DRAINAGE AND TRANSPORTATION SHEET
(REV. 1/28/2003rd)

PROJECT TITLE: Bruckner's Truck Sales ZONE MAP/DRG. FILE # J-09-Z
DRB #: 1008585 EPC #: _____ WORK ORDER #: _____

**RE: BRUCKNER'S TRUCK SALES,
DRAINAGE REPORT AND GRADING PLAN COMMENT RESPONSE
ENGINEER'S STAMP DATED: 7/19/12 (J09/DO21)**

SEP 21 2012

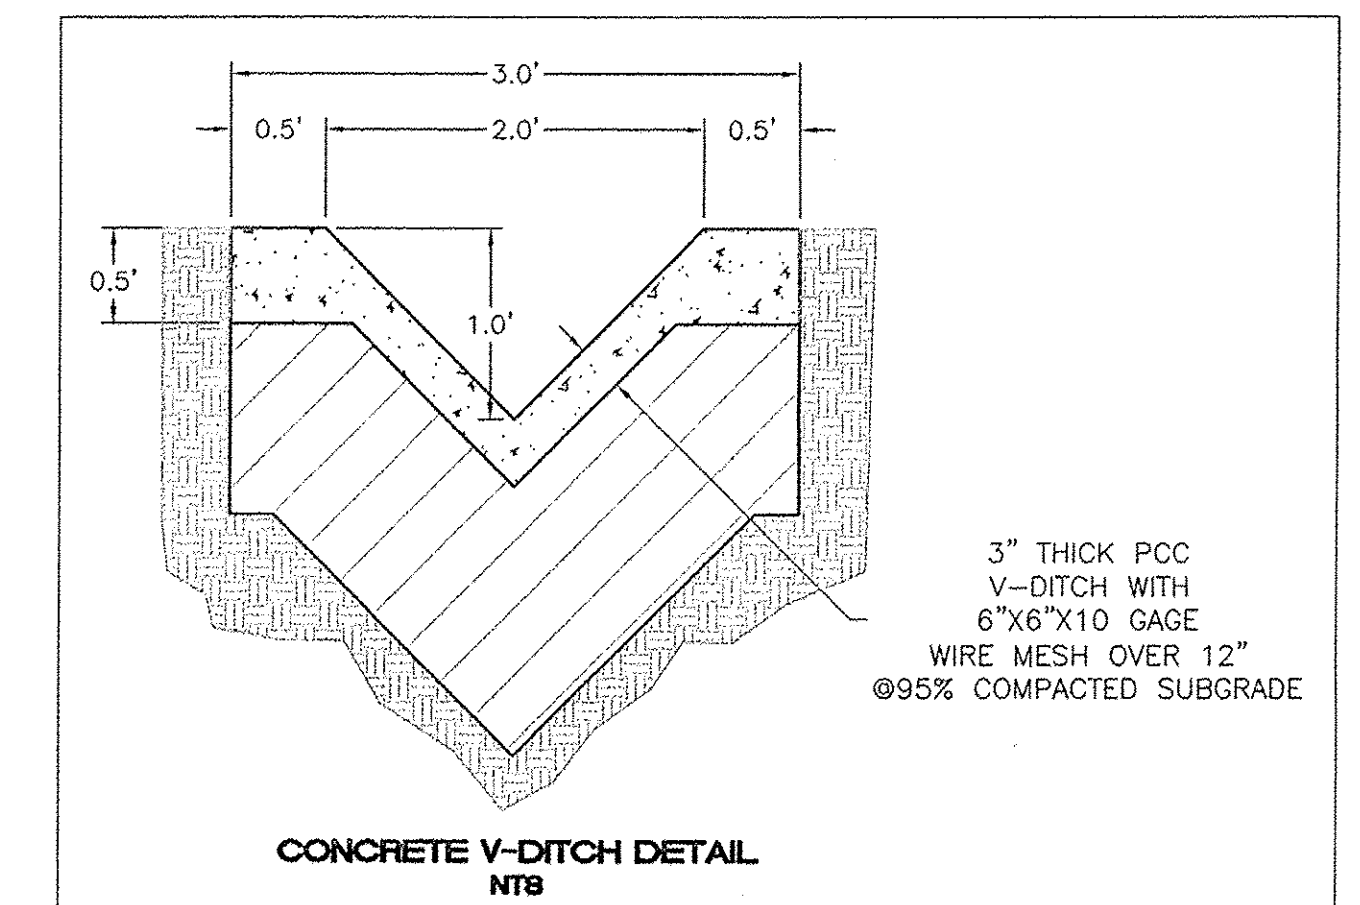
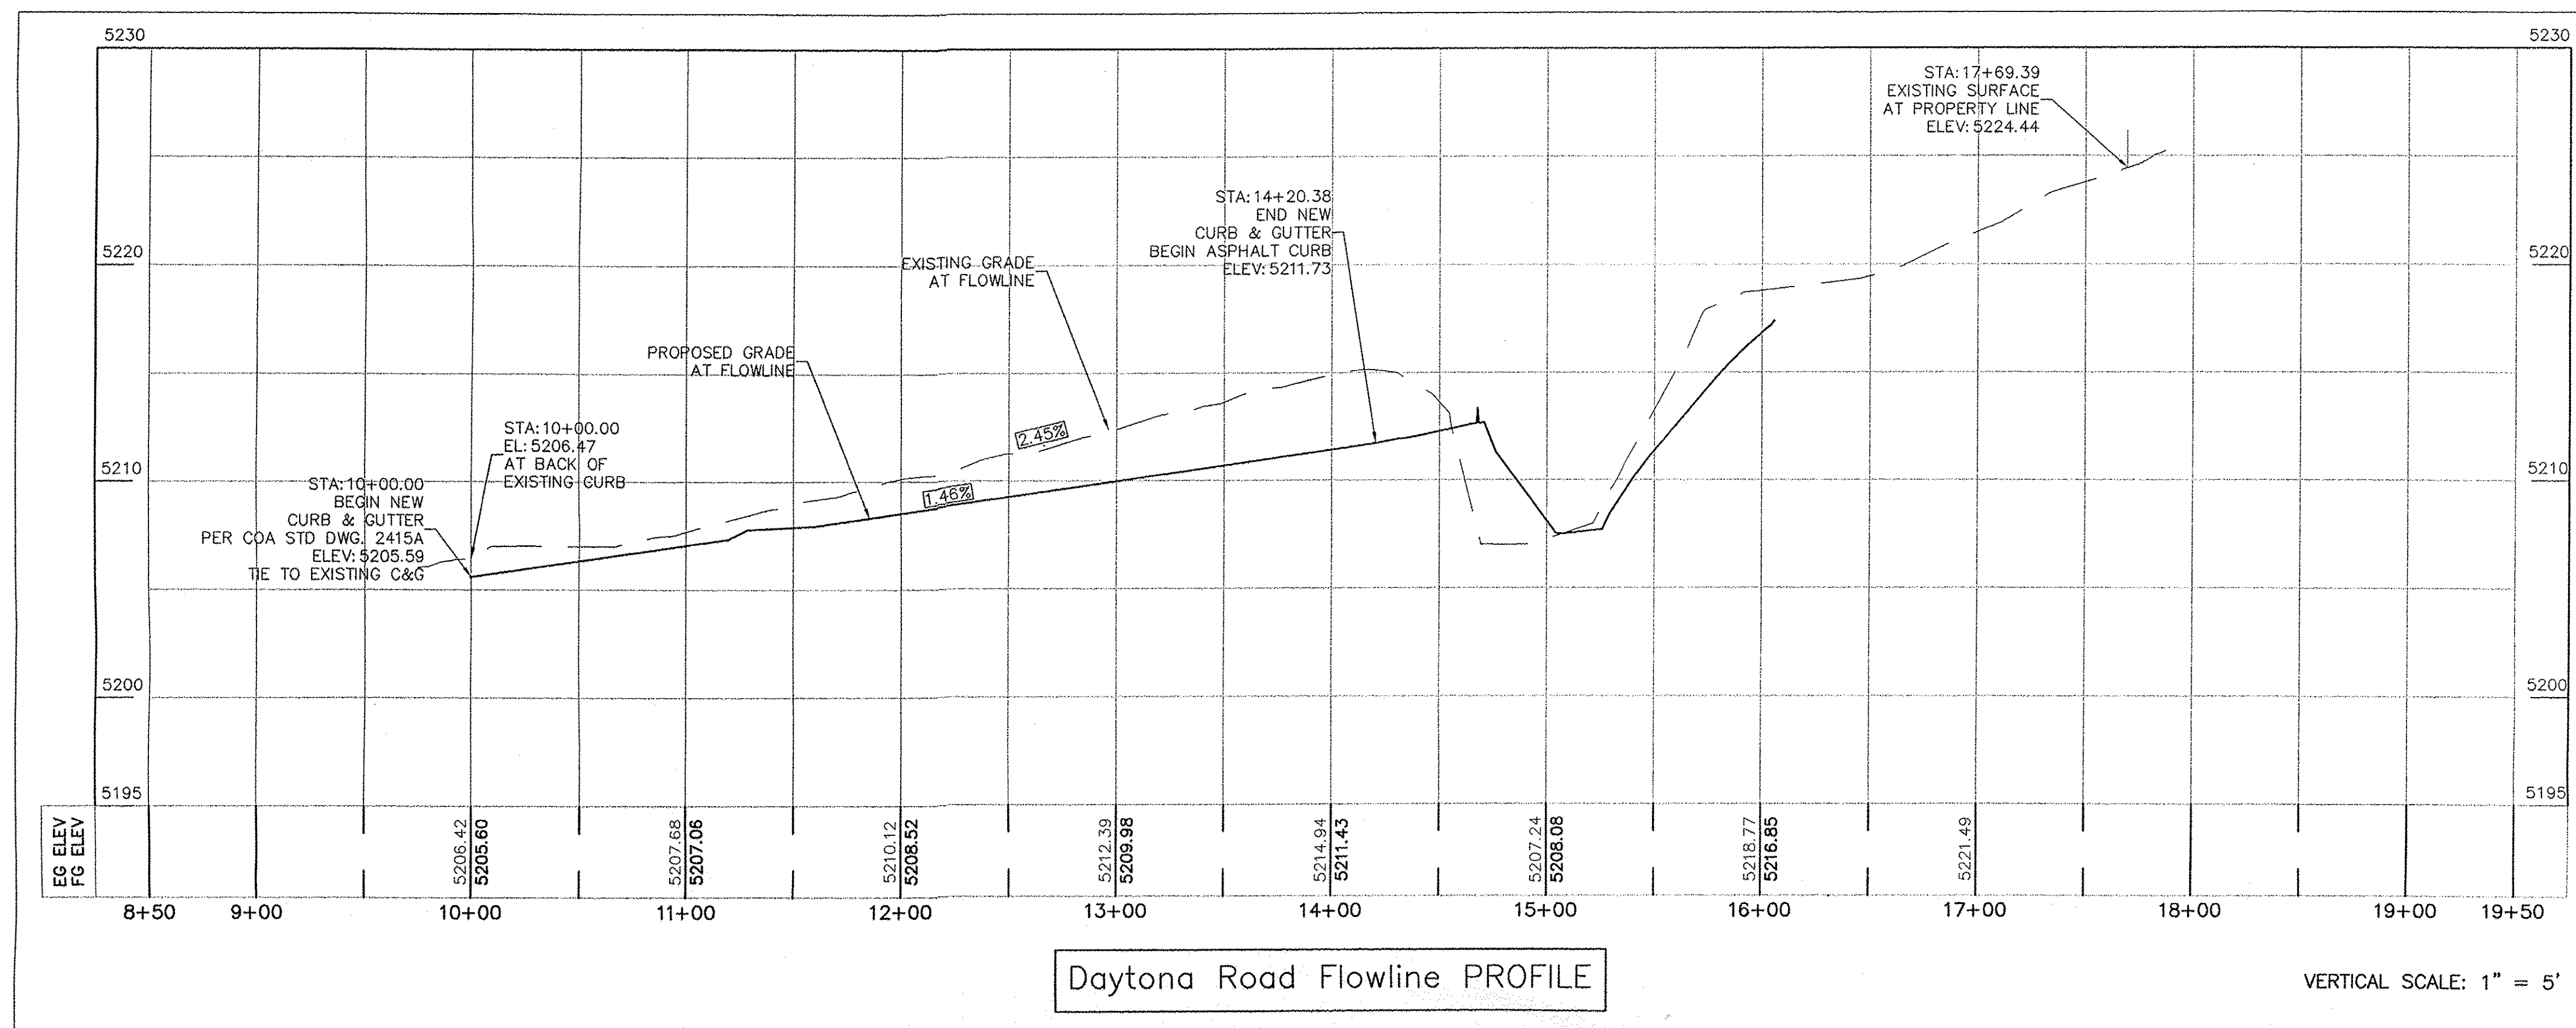
3. Please provide erosion and scour analysis passed the enclosed riprap for the channel. Would scour wall be required at the end of the riprap?
Attached, please find the channel analysis results for the area in question. The analysis shows that the velocities are within the acceptable range to prevent dangerous erosion and we have called out and detailed a cutoff wall for the end of the riprap and channel improvements.

< 5 fps, therefore okay
